Access Compliance Report Public Rights-of-Way (Curb Ramps)

Main Street: SILVER_FOX_RD Cross Street: TUCKER_LN Location: NE

ADA ID: RPRK211208130201 Ramp Type: Type 1 - Perpendicular Diagonal Initial Pass/Fail: Pass Overall Compliance: No Severity Score: 10

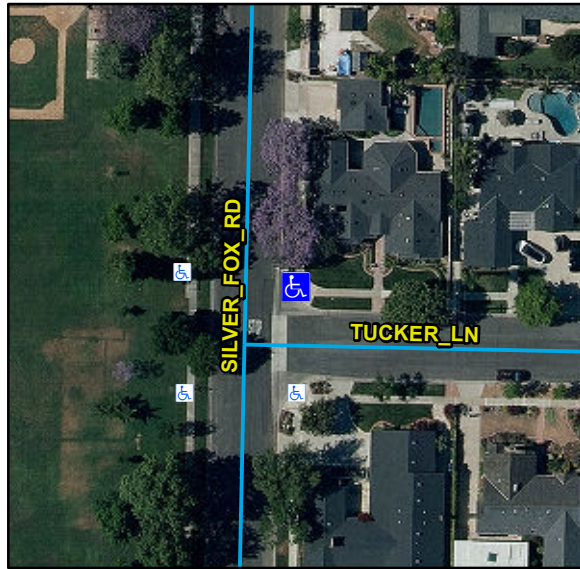
R204.3, R305, STD 1115

Compliance	Description	Data	Compliance	Description	Data
N/A	Ramp Length (in)	80	N/A	Flare Type LT	
Yes	Ramp Width (in)	48			Sloped
Yes	Ramp Run Slope (%)	3.6	N/A	Flare Slope LT (%)	3.7
Yes	Ramp Cross Slope (%)	1.8	N/A	Flare Traversable LT	No
N/A	Landing Present	Yes	N/A	Flare Type RT	
N/A	Landing Length (in)	50			Sloped
Yes	Landing Width (in)	48	N/A	Flare Slope RT (%)	7.5
Yes	Landing Run Slope (%)	1.8	N/A	Flare Traversable RT	No
Yes	Landing Cross Slope (%)	1.8	No	DWS Provided	No
N/A	Landing Movement Obstructed?	No	N/A	DWS Contrast	N/A
	Landing Movement Type	N/A	N/A	DWS Length (in)	N/A
N/A	Landing Shared	No	N/A	DWS Full Width	N/A
N/A	Clear Space	Yes	N/A	DWS Offset Left (in)	N/A
N/A	Clear Space To Crosswalk (in)	48	N/A	DWS Offset Right (in)	N/A
N/A	Marked Crosswalk 1	No	N/A	Marked Crosswalk 2	No
	Crossing 1 Direction	W		Crossing 2 Direction	S
	Marked Crosswalk 1 Width (in)	N/A		Marked Crosswalk 2 Width (in)	N/A

N/A	Ramp Inside Crosswalk 1	N/A	Yes	Ramp Inside Crosswalk 2	N/A
	Crossing 1 Slope (%)	7.2		Crossing 2 Slope (%)	2.8
	Crossing 1 Cross Slope (%)	2		Crossing 2 Cross Slope (%)	1.7
Yes	Gutter Ponding	No	Yes	Curb Slope	0.5
Yes	Gutter Lip Height (in)	0		Road Run Slope (%)	2.4
Yes	Gutter Run Slope (%)	0		Road Cross Slope (%)	0.9
Yes	Gutter Cross Slope (%)	1.4			
Yes	Overall Surface Condition: Acceptable		No	Perp Joint Present	No
	Cross Gutter Present?	Yes		Spandrel Present?	Yes
	Replace Cross Gutter?	No		Replace Spandrel?	No

Remove & Replace Curb Ramp With Two New Directional Ramps or Equivalent.
